PREVOST

**SAFETY
RECALL**

SR15-03A

DATE :	MARCH 2015	SECTION :	23 - Accessories
SUBJECT:	KIDDE HAND FIRE EXTINGUISHER INSPECTION AND REPLACEMENT

Figure 1 : Typical seated coach position

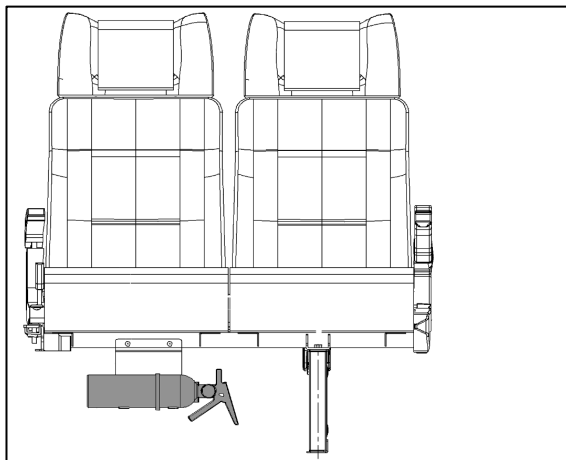
1. Locate the two (2) hand held extinguishers in the vehicle.

In seated coaches, they are typically attached under the front row seats, left and right.(Fig. 1)
